Product Change Notice (PCN)

PCN Number: PCN-0450001R-01

Product(s) Affected:
SJ-3501-SMT-TR

Recommended PCB Layout
Top View

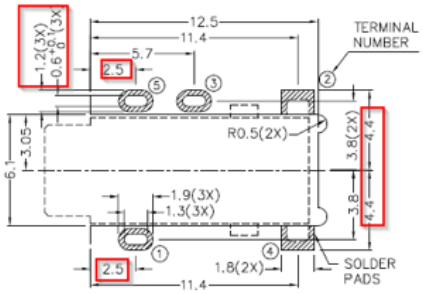
2. PCB pad/hole size differs
